WILDWOOD MANOR SHOPPING CENTER – PART OF PARCEL C
PRELIMINARY PLAN AMENDMENT NO. 11989271D
SITE PLAN AMENDMENT NO. 82008024C

No. 11989271D, 82008024C
Completed: 2-14-2022

MCPB
Item No.
02-24-2022

Figure 3 - Architectural Facade Material Upgrades

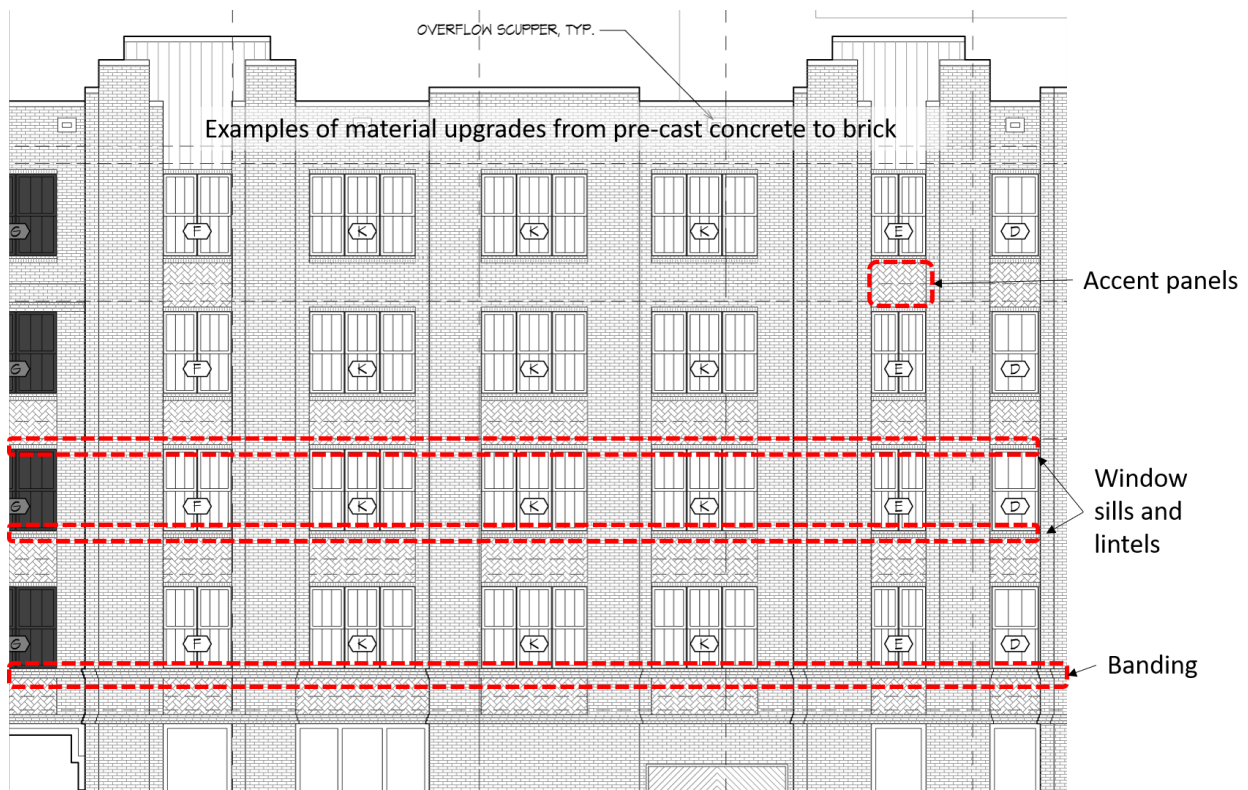
The proposed mixed-use building will be built using buff-colored brick in an Art Deco style, with decorative elements that mimic the brushed metal accents common to that period. Architectural elements including lighting and signage will complement the overall aesthetic. The articulation of the proposed building breaks up the massing, while the vertical elements on the facades add interest and decrease the scale. This Amendment upgrades pre-cast concrete façade materials to brick, creating a more unified design while still maintaining the basic design elements.

Figure 5 - Minor Improvements

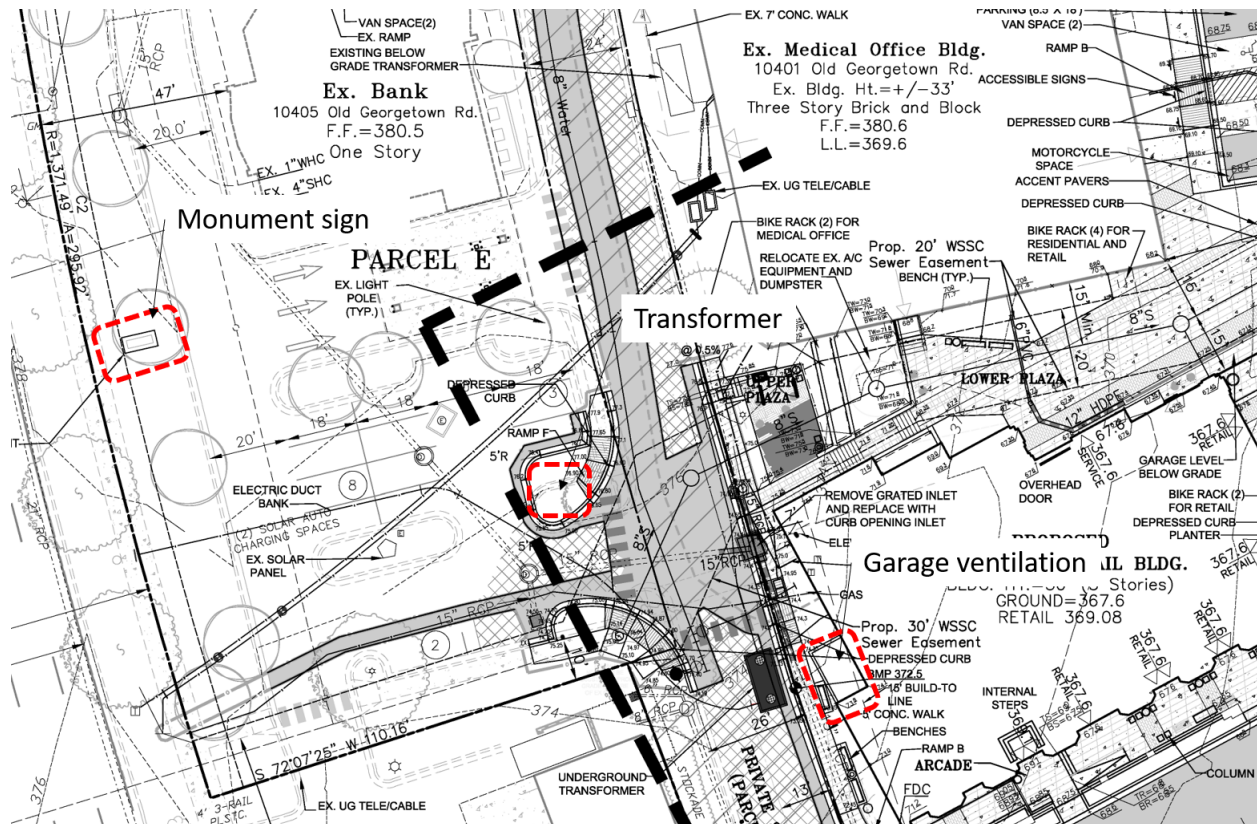
The Site Plan Amendment includes the addition of a monument sign on Old Georgetown Road and ventilation for the below grade parking garage. A transformer will also be buried.

Figure 6 - Previously Dedicated Right-of-Way

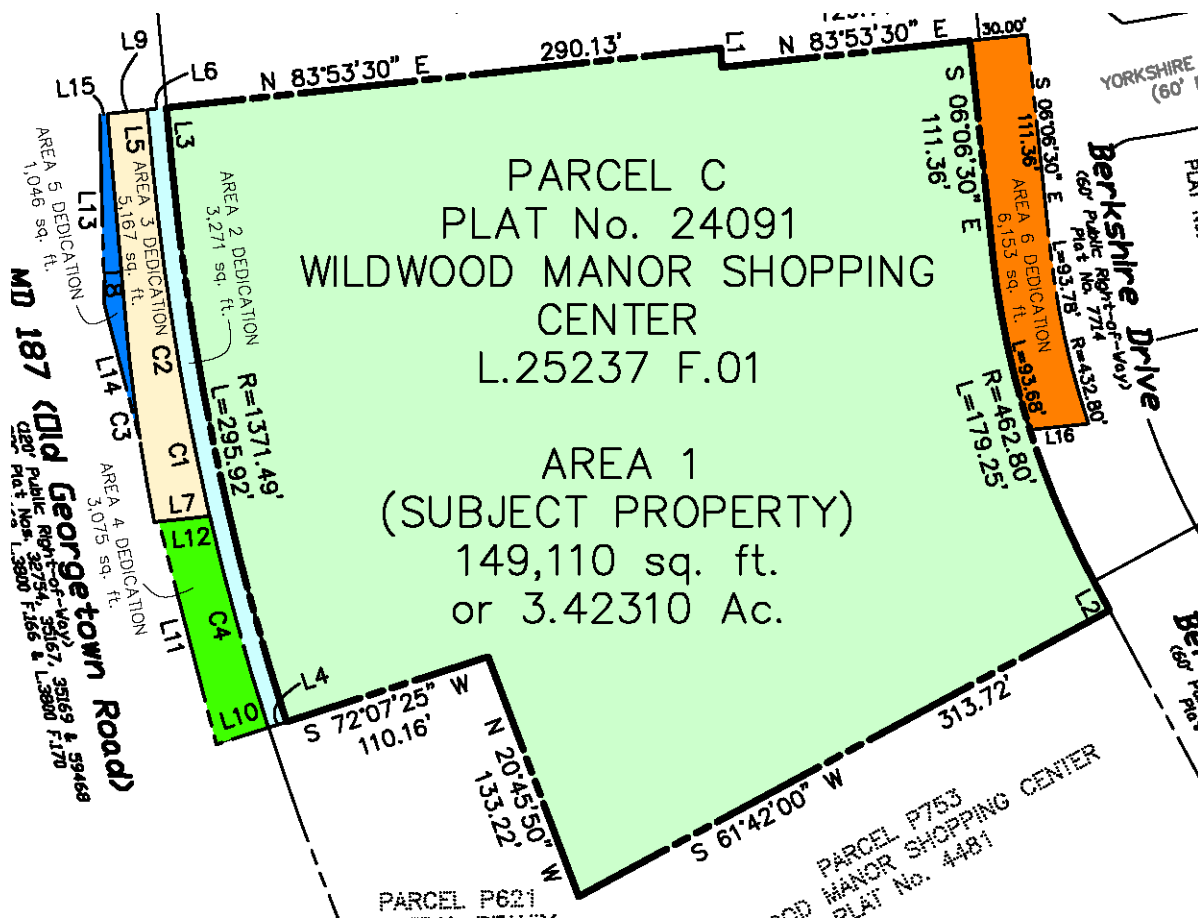
According to Section 59.4.1.7.A.1, "A tract is a contiguous area of land, including all proposed and existing rights-of-way, lots, parcels, and other land dedicated by the owner or a predecessor in title. A tract does not include land conveyed to a government for more than nominal consideration." The tract area shown on prior plan approvals did not include previously dedicated right-of-way. These amendments correct the tract area by including right-of-way dedicated for Berkshire Drive and Old Georgetown Road, as documented by record plats. While the tract area is increasing, no additional development is proposed with these applications. The number of dwelling units is increasing without increasing the square footage of residential development through changes in unit types and sizes. The site area is 3.423 acres while the tract area is 3.85 acres.
